**Verification and certification report form for  
CDM project activities  
(Version 02.1)**

<b>Title and UNFCCC reference number of the project activity</b>	Taegisan Wind Power Project (Ref. 2302)
<b>Version number of the verification and certification report</b>	Version 02.0
<b>Completion date of the verification and certification report</b>	27/03/2019
<b>Monitoring period number and duration of this monitoring period</b>	6 <sup>th</sup> monitoring period, 01/01/2018-31/12/2018
<b>Version number of the monitoring report to which this report applies</b>	Version 02.0
<b>Crediting period of the project activity corresponding to this monitoring period</b>	15/05/2009 ~ 14/05/2019 (10 years)
<b>Project participants</b>	- POSCO Engineering and Construction Co., Ltd. - Eurus Energy Holdings Corporation
<b>Host Party</b>	- Republic of Korea(host) - Japan (Annex I country)
<b>Applied methodologies and standardized baselines</b>	Methodology : ACM0002 (Version 07) Selected standardized baseline : N/A

Eurus Energy Holdings Corporation has commissioned Korea Testing and Research Institute (hereinafter referred to as “KTR”) to carry out the 6<sup>th</sup> verification of the project titled “T

Transmission line maps before and after the revision are compared below:

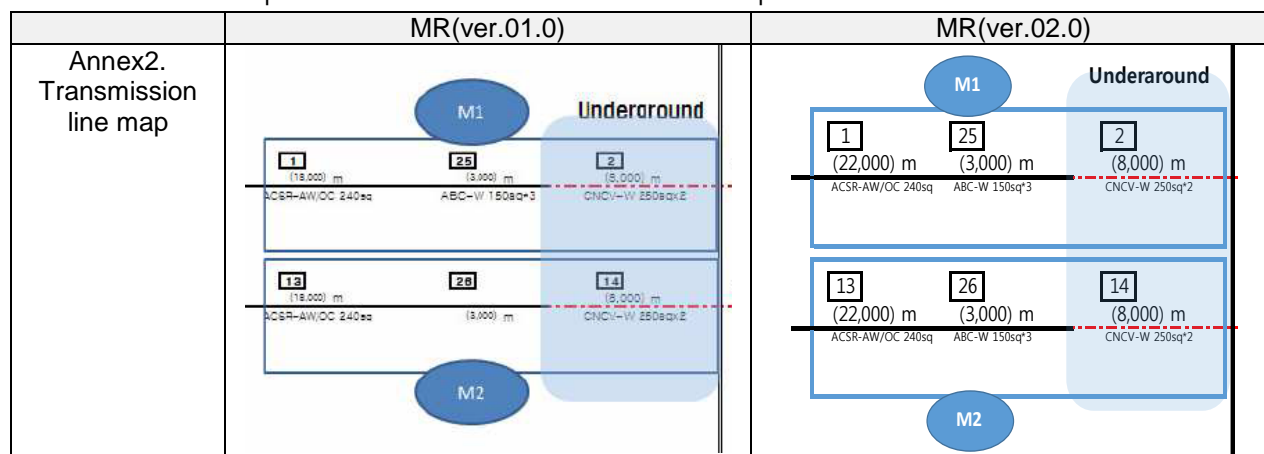
CAR ID	Section no.	Date:
CAR1	E.3	12/02/2019
Description of CAR		
The verification team found out that the data on the length of transmission line given in the transmission line map in Annex 2 of the MR is not consistent with the data used in the ER calculation sheet.		
Project participant response		
Date: 14/02/2019		
The PP submitted the revised MR (ver. 02.0) which includes a corrected transmission line map in Annex 2.		
Documentation provided by project participant		
The revised MR (ver. 02.0) <sup>10/</sup> .		
DOE assessment		
Date: 15/02/2019

The verification team confirmed that the transmission line map in Annex 2 of the revised MR (ver. 02.0)<sup>10/</sup> is appropriately corrected.

The verification team confirmed that the transmission lines are consist of 22km of single phase overhead line, 3 km of triple phase overhead line, and 8 km of underground line, and that ER calculations in the ER calculation sheet (ver. 01.0) have been performed appropriately using the correct line length value for each transmission line mentioned. The length of the transmission lines are confirmed by 'Electricity transmission line map'<sup>15/</sup> and interview.
